## Response to TCB Findings

Freq. Response of Audio

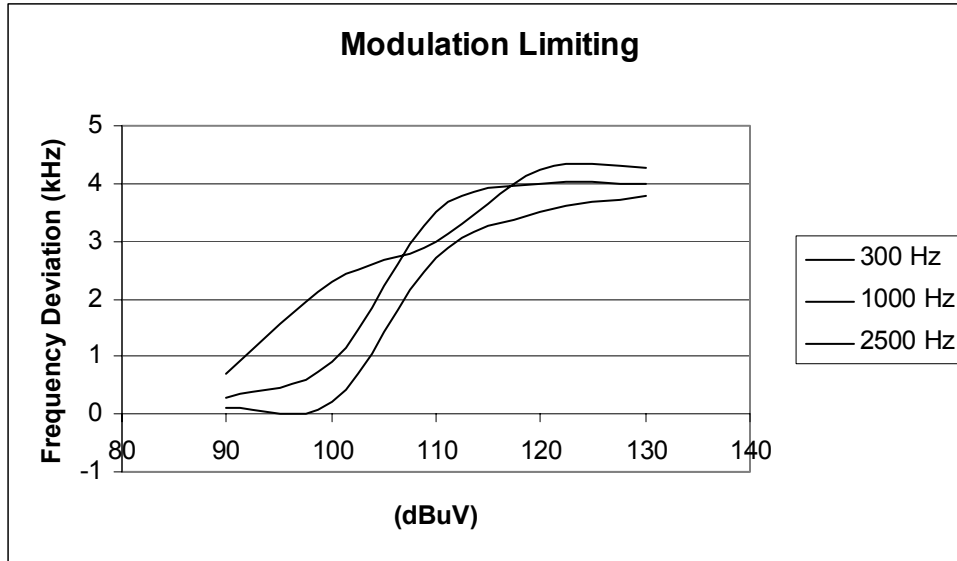
1. A curve or equivalent data showing the frequency response of the audio modulating circuit over a range of 100 to 5000Hz shall be supplied as required by 2.1047(a).

VT-4D150, Modulation Limiting  
WB

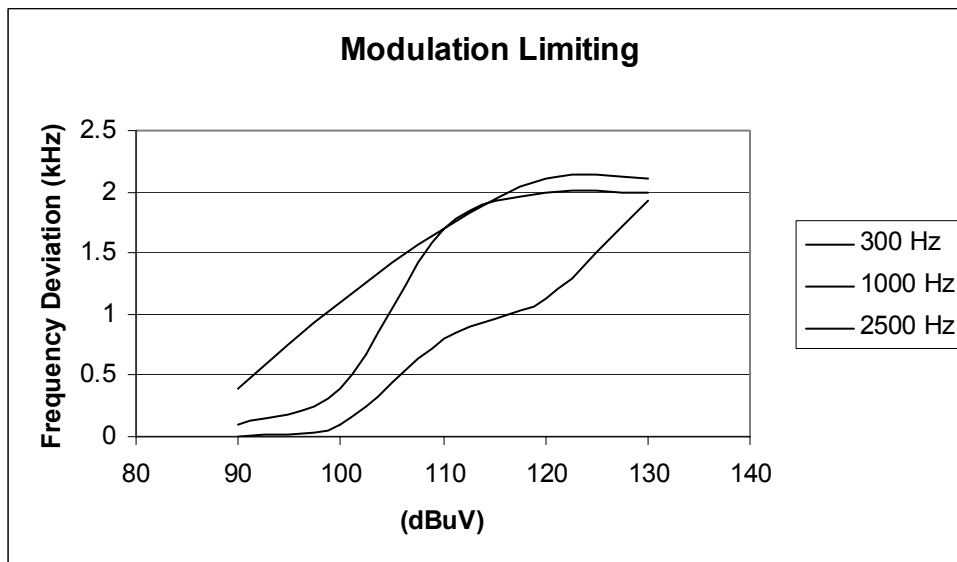
2. Please supply modulation limiting curve required by 2.1047(b).

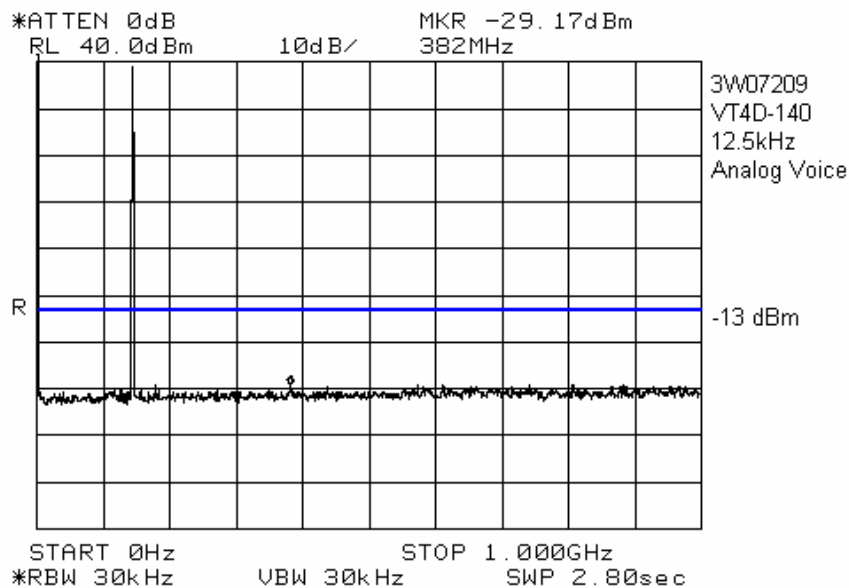
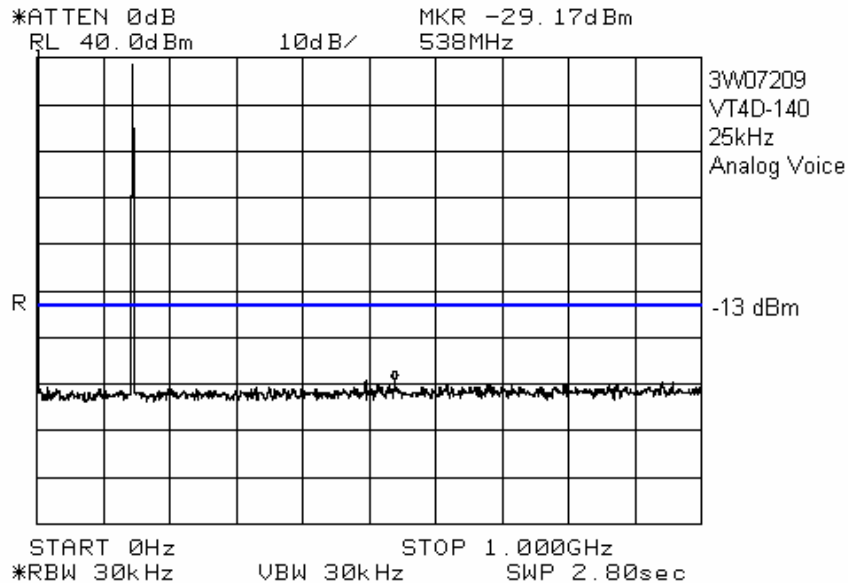
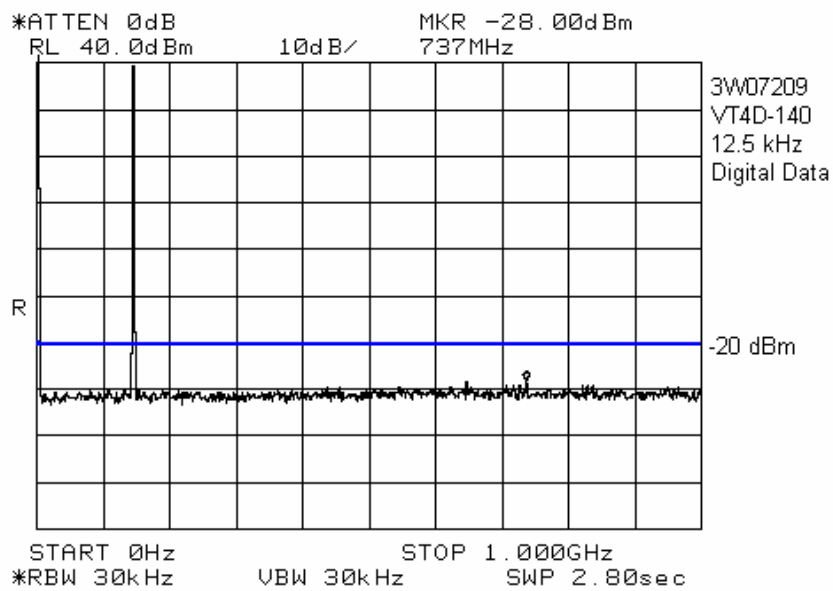
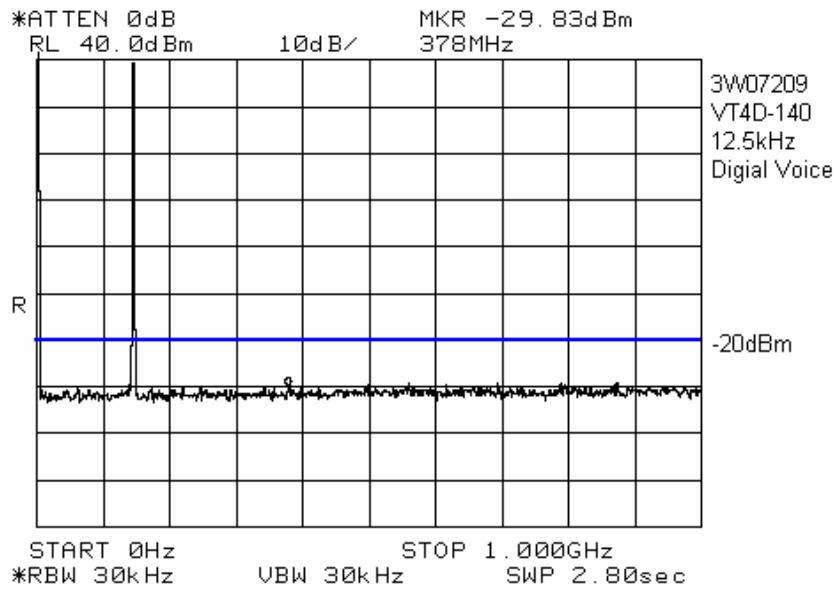
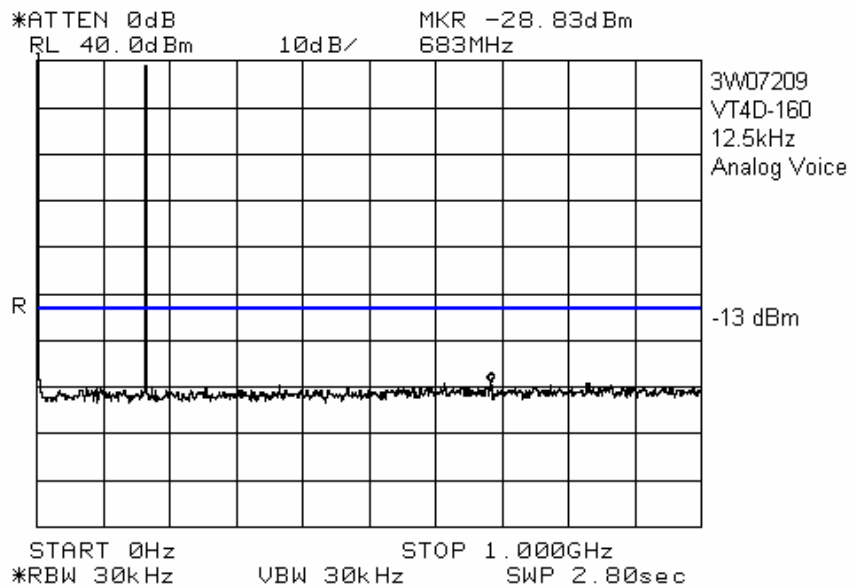
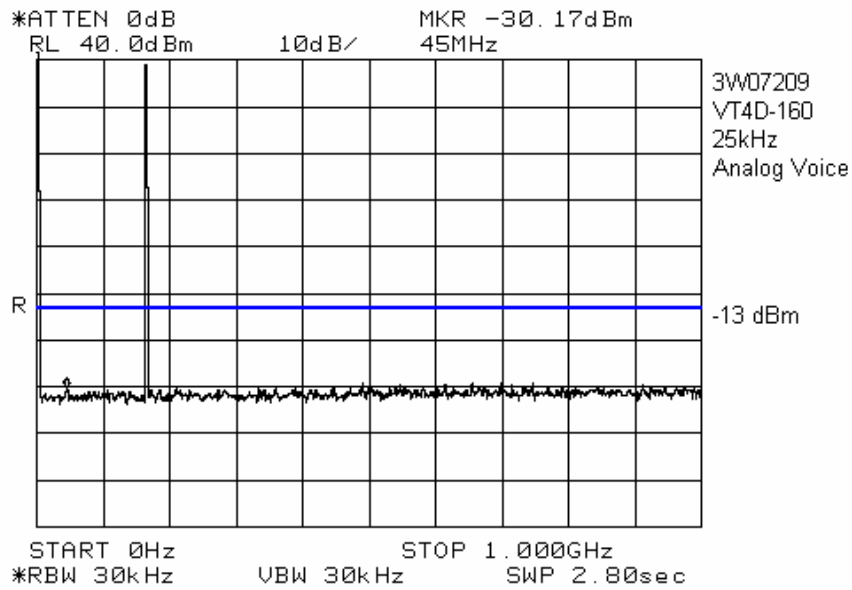
3. For some of the spurious emissions at the antenna terminal plots the in the test report RBW is set to 10kHz. The minimum RBW setting should be 30kHz according to 22.359(c). Please justify/clarify this selection

This test caused a dilemma. Part 22 and Part 90 have different requirements. P22 uses 30 kHz, P90 uses at least 10kHz(see 90.210(m)). I showed 10 kHz assuming it would be relatively easy to calculate emission peaks from a 10 kHz to 30kHz RBW/VBW. It would also show a truer representation of the EUT, by lowering the N.F. of the analyzer. See attached plots.
